Subject: Improvement of the performance map of the new IAE50R-AA ECU with serial numbers "AE00XXX" which were installed as standard from 2014 onwards.

Applicability: **ASH 31 Mi**; Type-Certificate EASA.A.538; all serial numbers
Only aircraft with ECU serial number beginning with AE and revision 020 or AA1 are affected, see also "Reason".

Classification: Minor Change

Fig. 1: Affected ECU version

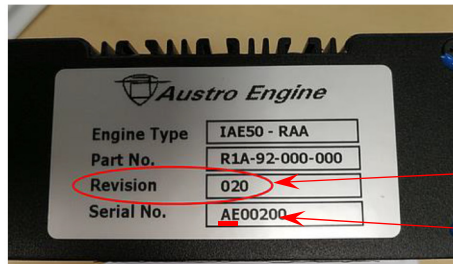
The revision is 020 (or even AA1)

The serial number starts with AE

Action: Send the removed ECU to A. Schleicher GmbH or Austro Engine to upload the new software with the version number "SW_V1.1.9.2.4".

Fig. 2: Change of the revision number after the update

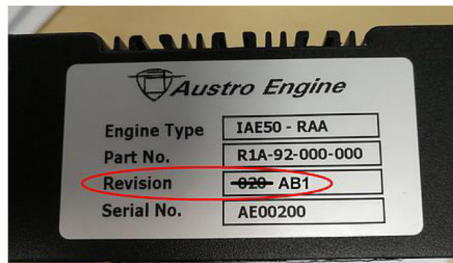
With removed or easy accessible ECU affix a new identification plate onto the original one or carry out the change with a wipe-resistant marker (permanent marker).
